ARGONNE NATIONAL LABORATORY

CT-1557
PDR 041483

February 15, 1983

Attached is a brief review of NUREG/CR-2497, "Precursors to Potential Severe Core Damage...". Because my schedule restricted my review and report to ~ 2 days, I have concentrated on two items: 1) an overview of what the findings mean vis-a-vis existing PRAs and actual severe core damage experience (i.e. TMI-2); and 2) items in the report's methodology that might have caused differences between report findings and the findings of existing PRAs. Since my review was performed prior to my receiving the INPO review, some of my comments overlap INPO's. However, nothing INPO related in their report appeared to affect my opinions as related herein.

Figure 1. 95% Confidence Bounds for SCD Frequencies Given 0, 1, 2, or 3 "Occurrences"

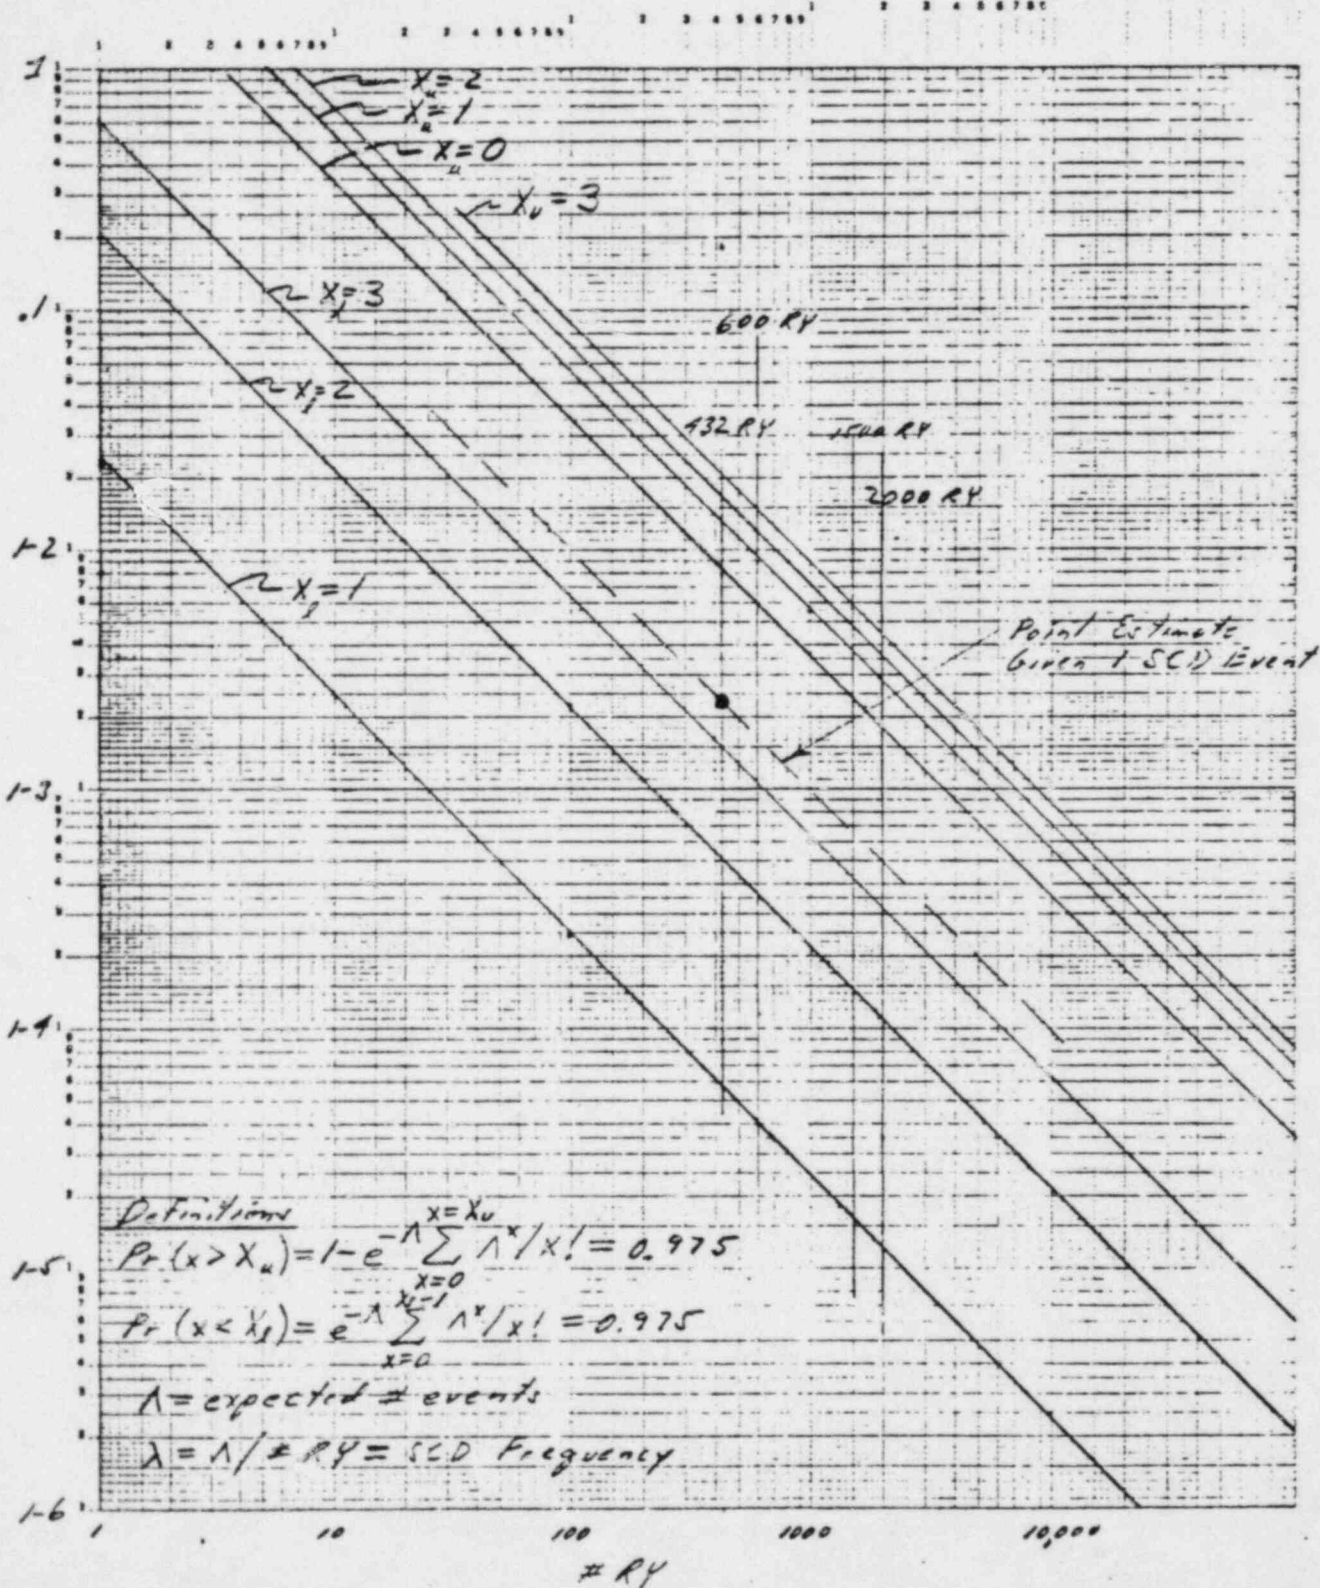
4. There is such a tremendous uncertainty that all estimates are equally acceptable. Figure 1 plots Poisson 95% confidence bounds as a function of number of reactor years operating experience for 0, 1, 2, and 3 SCD events. Interestingly, another SCD event such as TMI-2 would raise the current lower bound frequency based on 1 SCD, i.e. TMI, by an order of magnitude. As it stands now most PRAs appear to predict core melt frequencies somewhat optimistically if TMI is considered a "representative" statistic, especially if only U. S. experience is considered in the data base.
